ADDENDUM NUMBER ONE (1)

Issued 04/24/2025

Project: INNER PERIMETER ROAD UTILITIES EXTENSIONS

Project No. 25-05-702

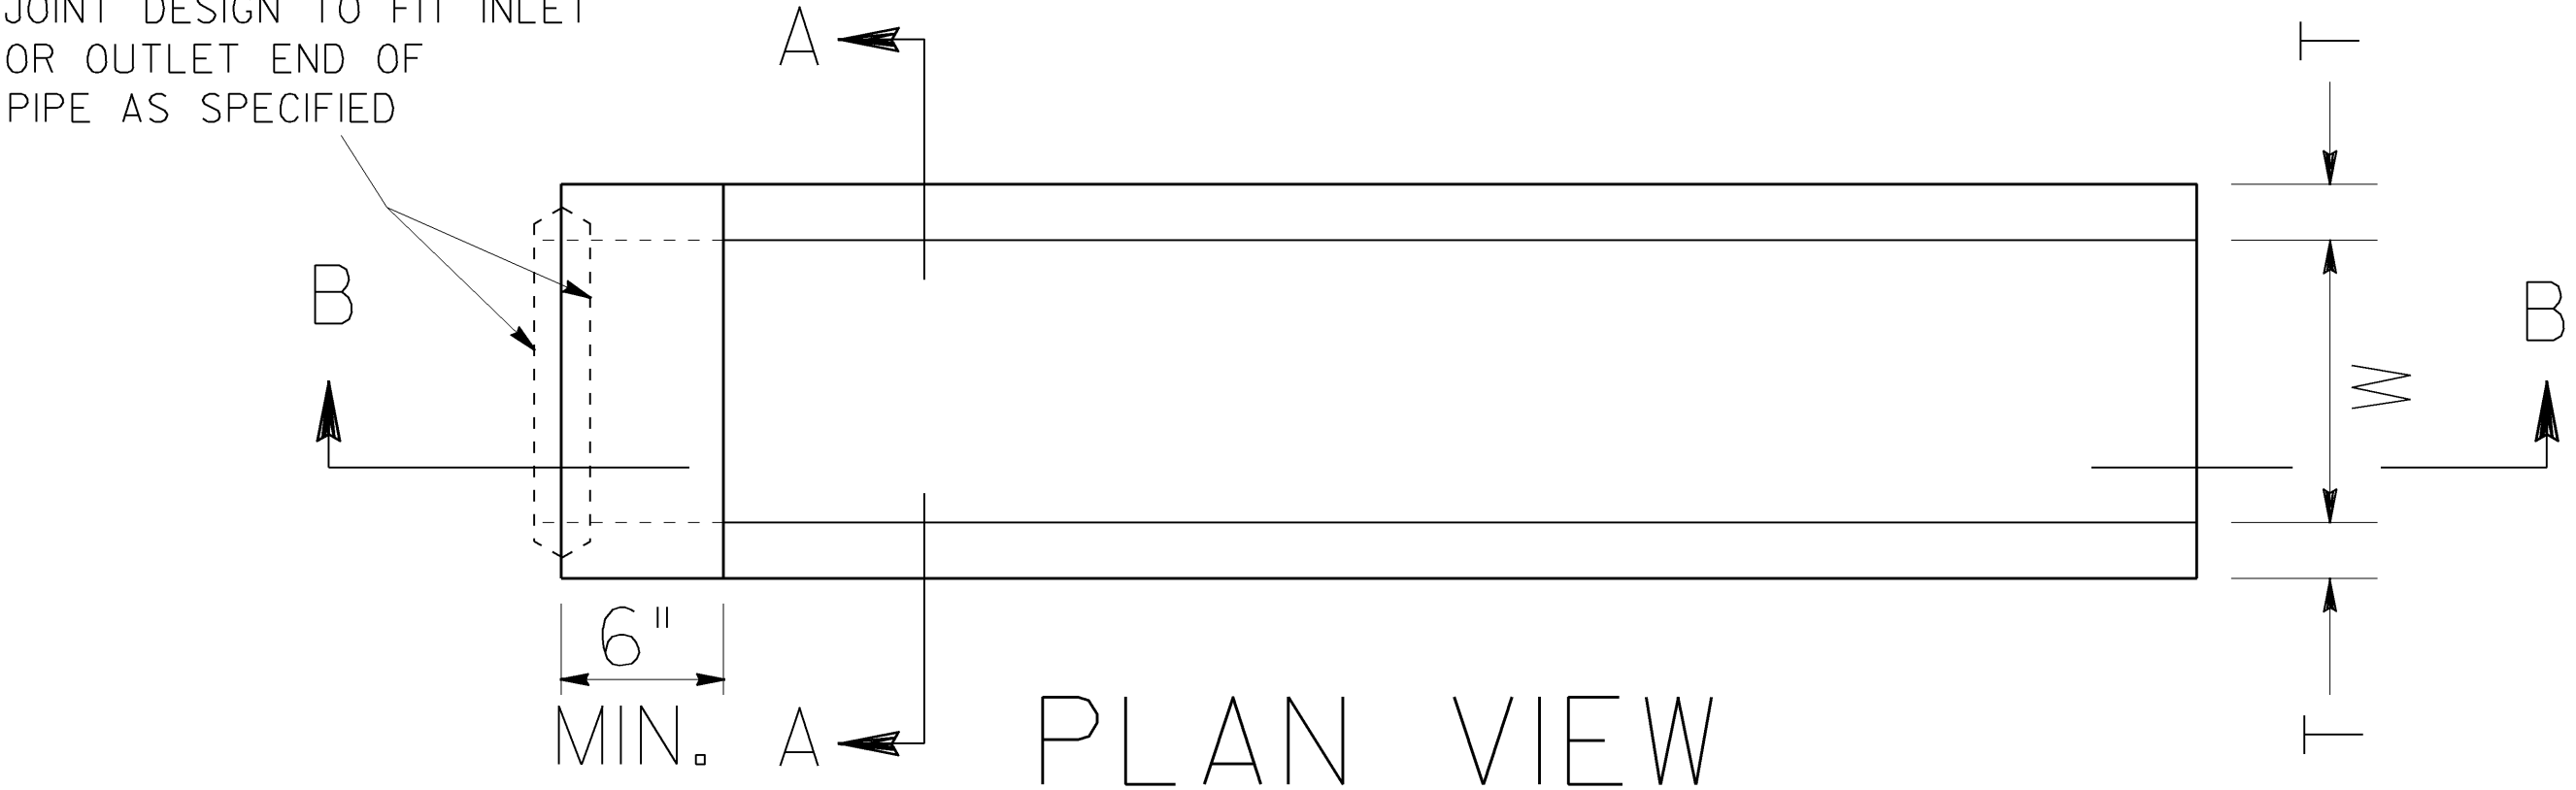
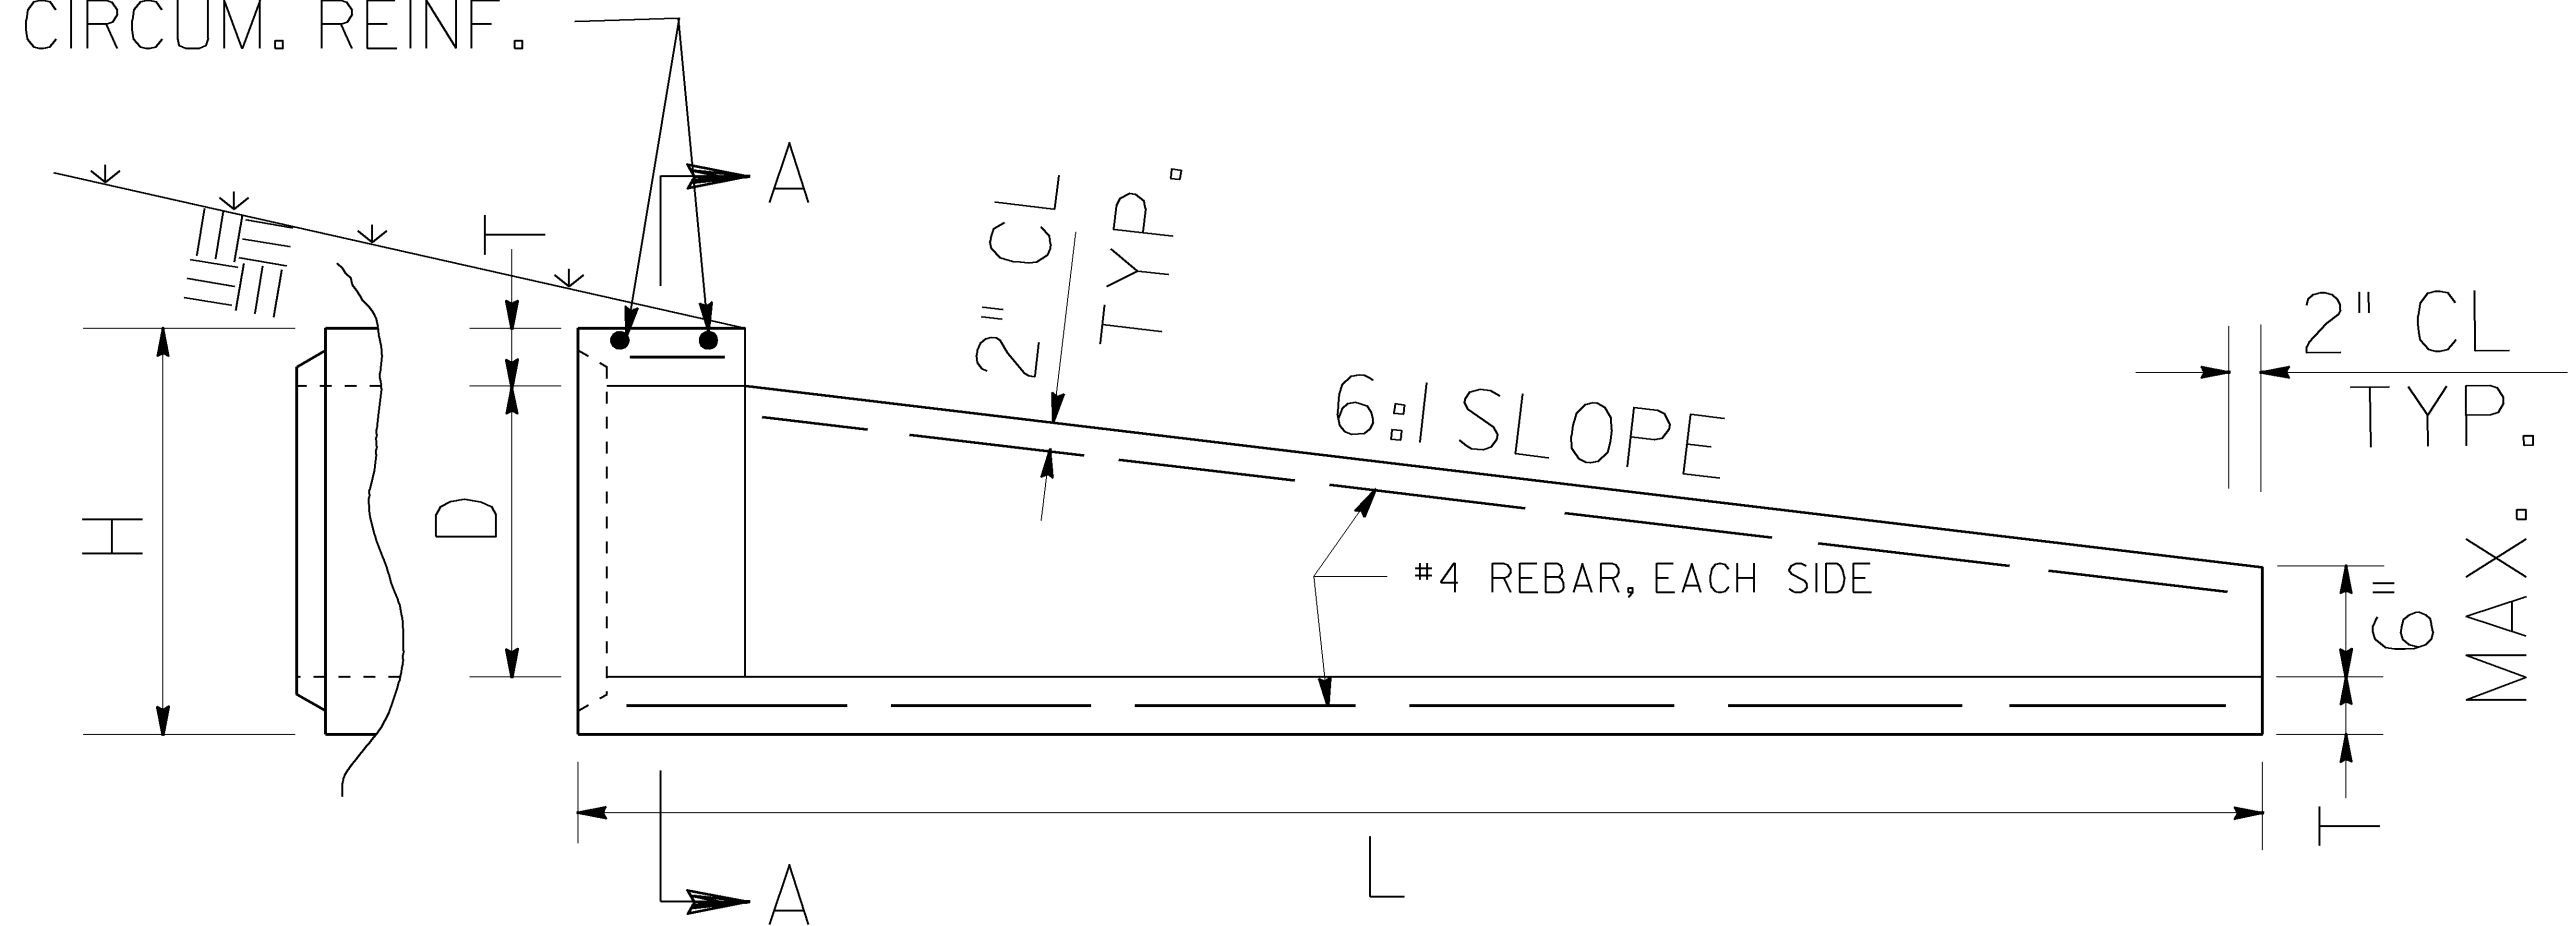
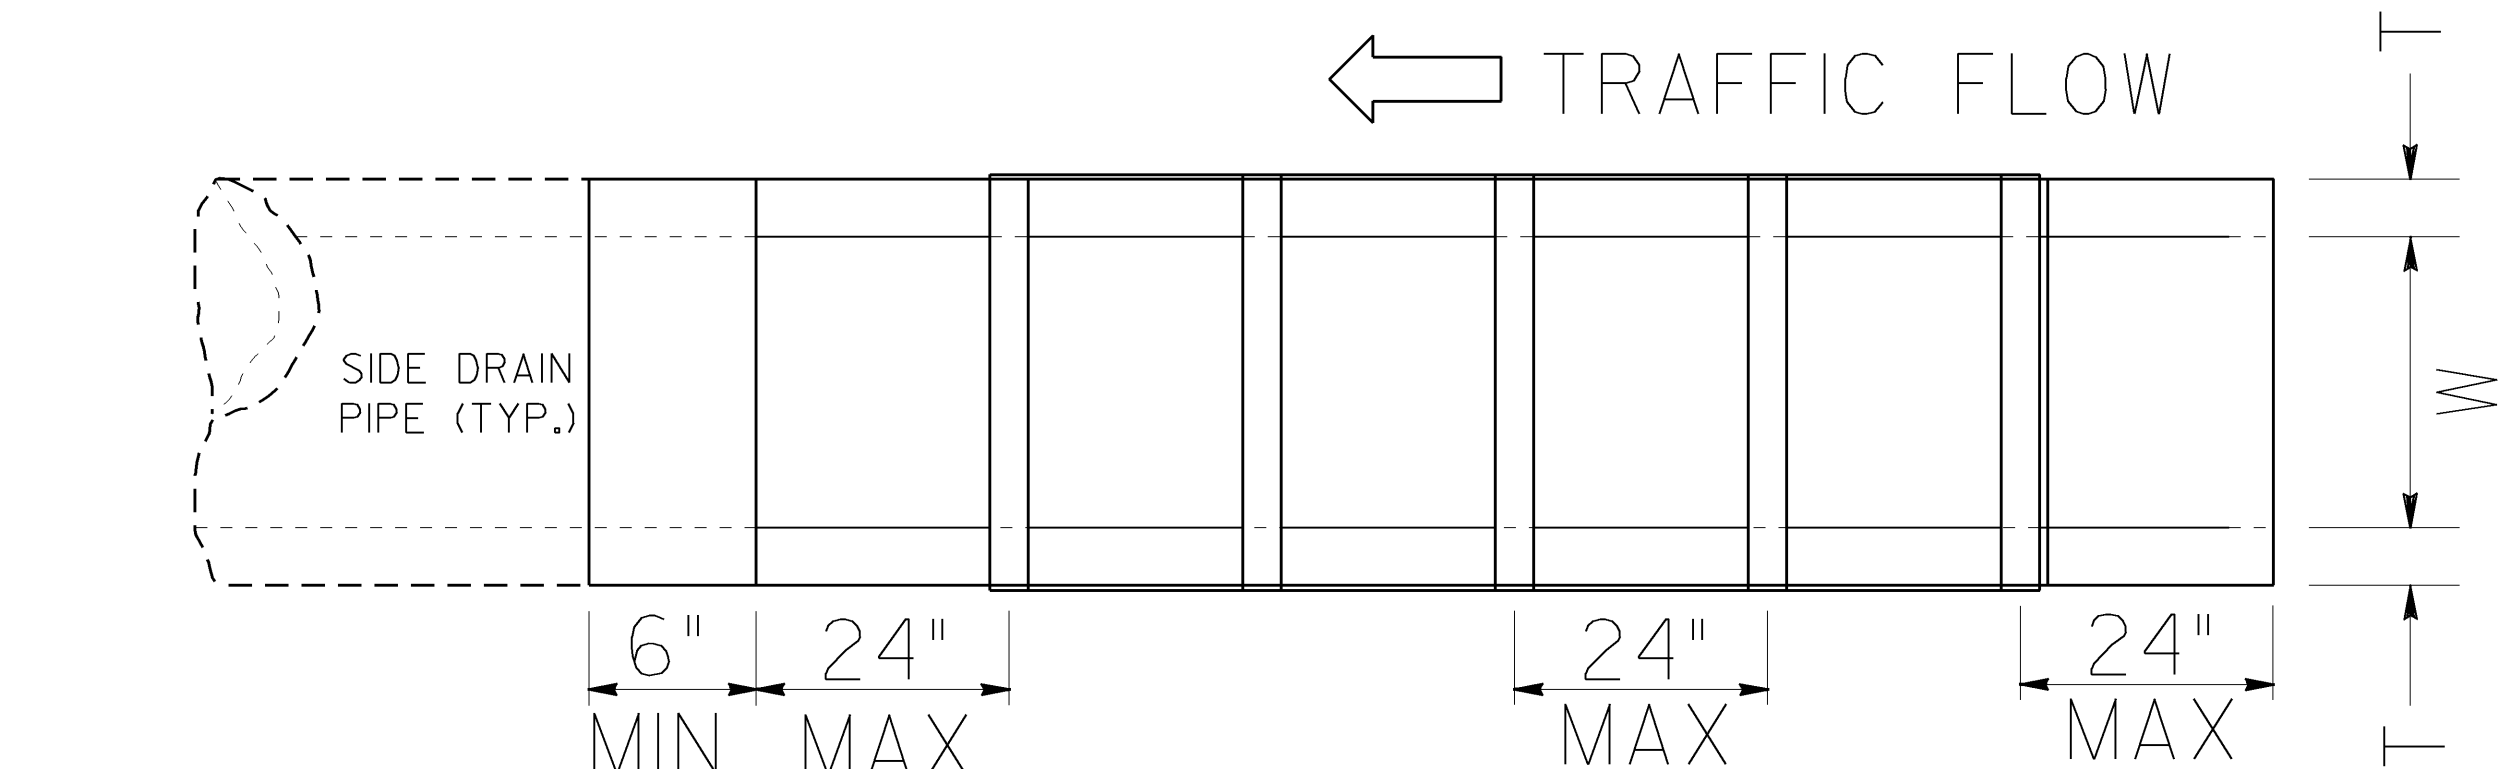
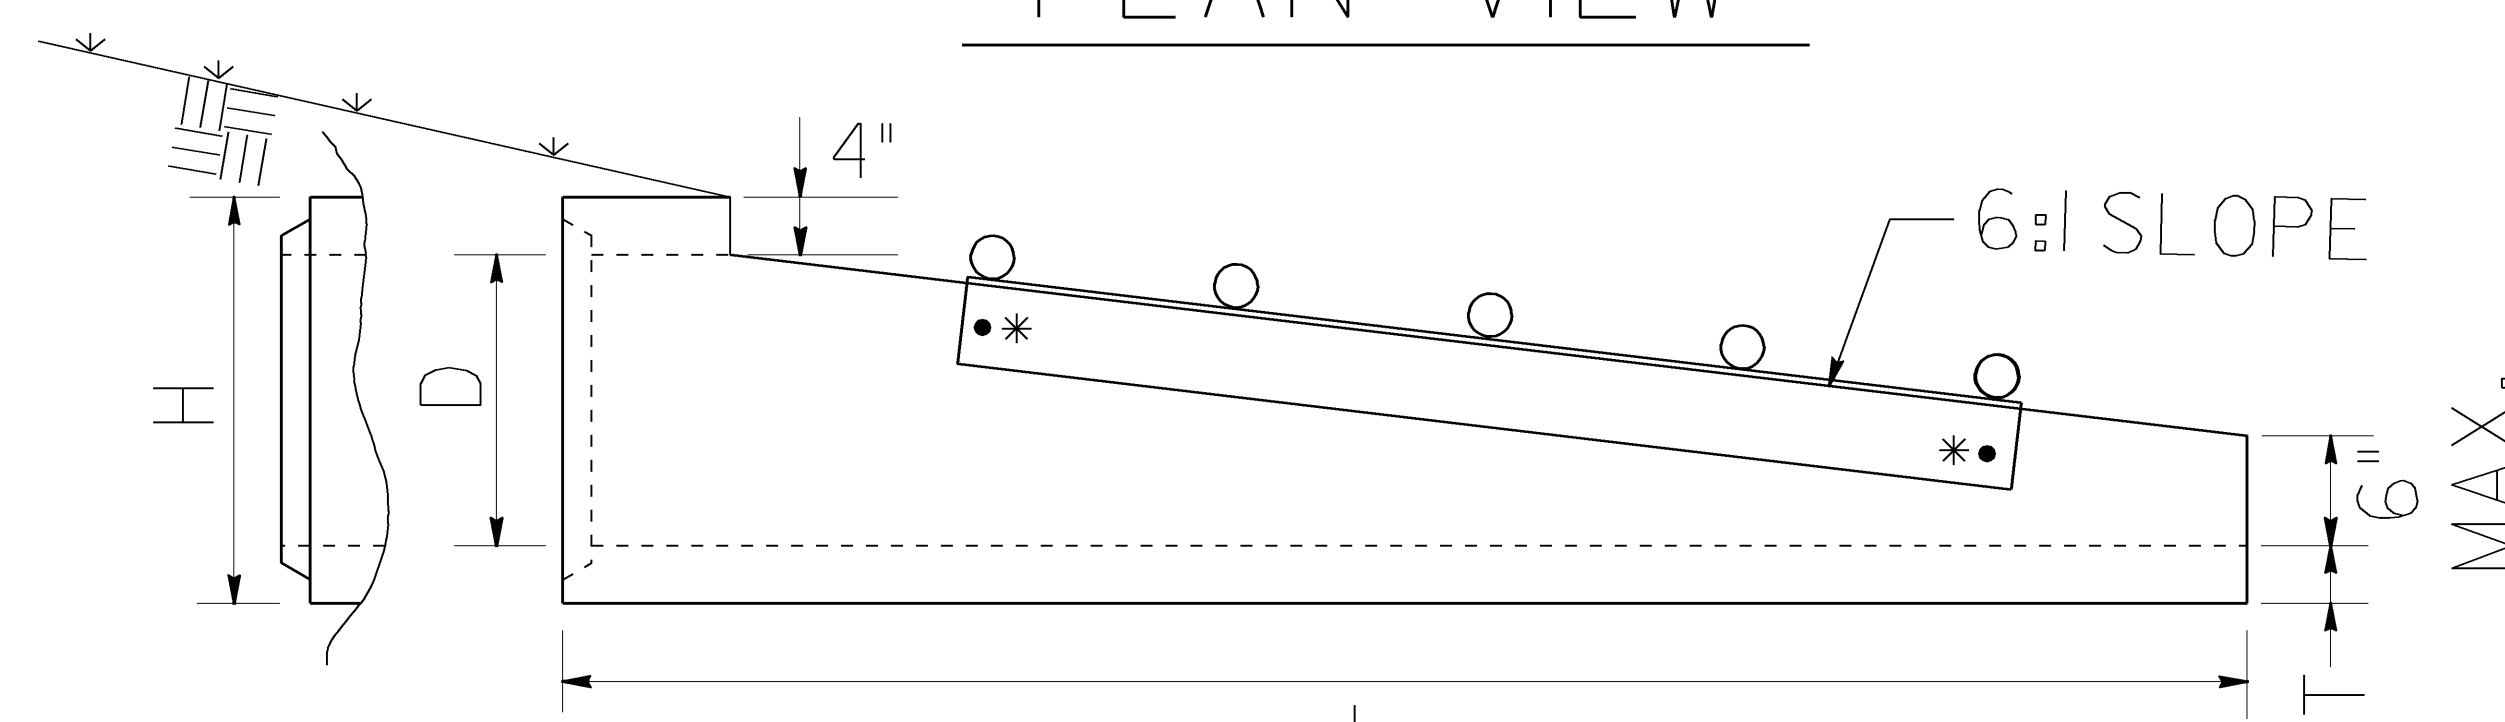
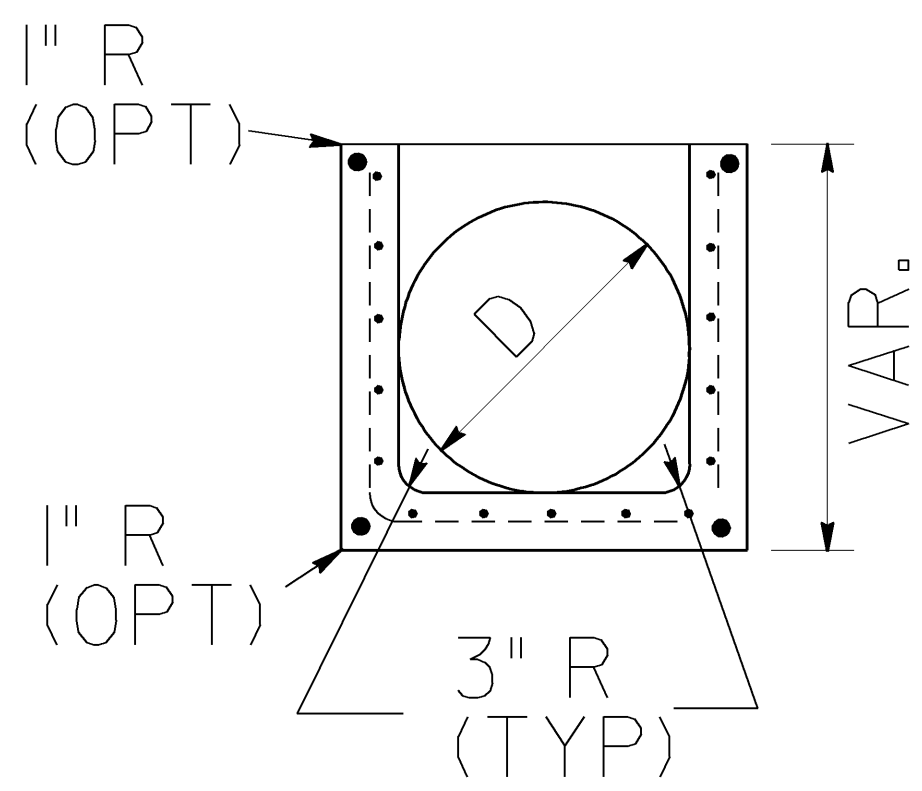
7. RCP & SES at pump station: does it have to be DOT stamped? GUY RENTZ OF THE GDOT AREA OFFICE STATES: "Safety Ends must meet GDOT Standard (1122-3). No DOT inspection stamp required. (attached standard)"
